Addendum 10

Request for Information 3

10/04/22

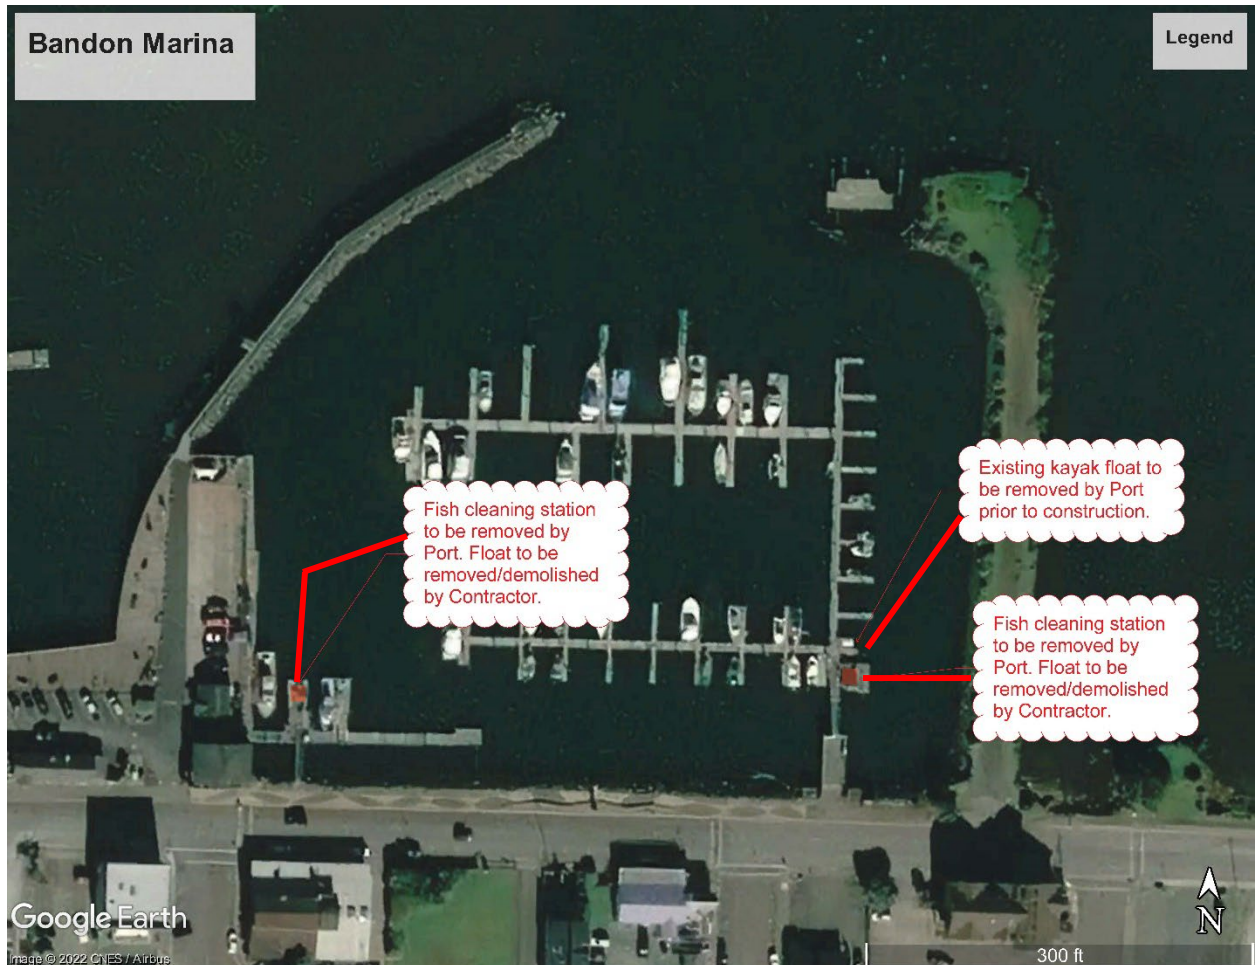
3. Please provide Details of Existing Fuel System and Equipment currently on site along with the modifications expected to be performed to the Fuel System to accommodate the installation of the New Floating Docks. What weight of the existing Fuel System should be accommodated by the new Floating Docks? Will only piping and a fuel reel be installed on the new floating dock? What is the current model and weight of the equipment to be salvaged?

A: The fueling system will remain on the high dock adjacent to Float D.
